ADA Curb Ramp New Construction Inspection Form (Perpendicular)

Nw 293rd

23885.56

Nw King

PERPENDICULAR RAMP (PR)

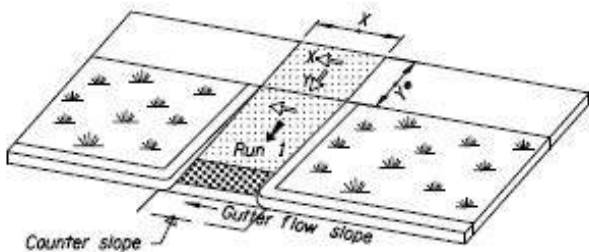
IITD RR 1 fails
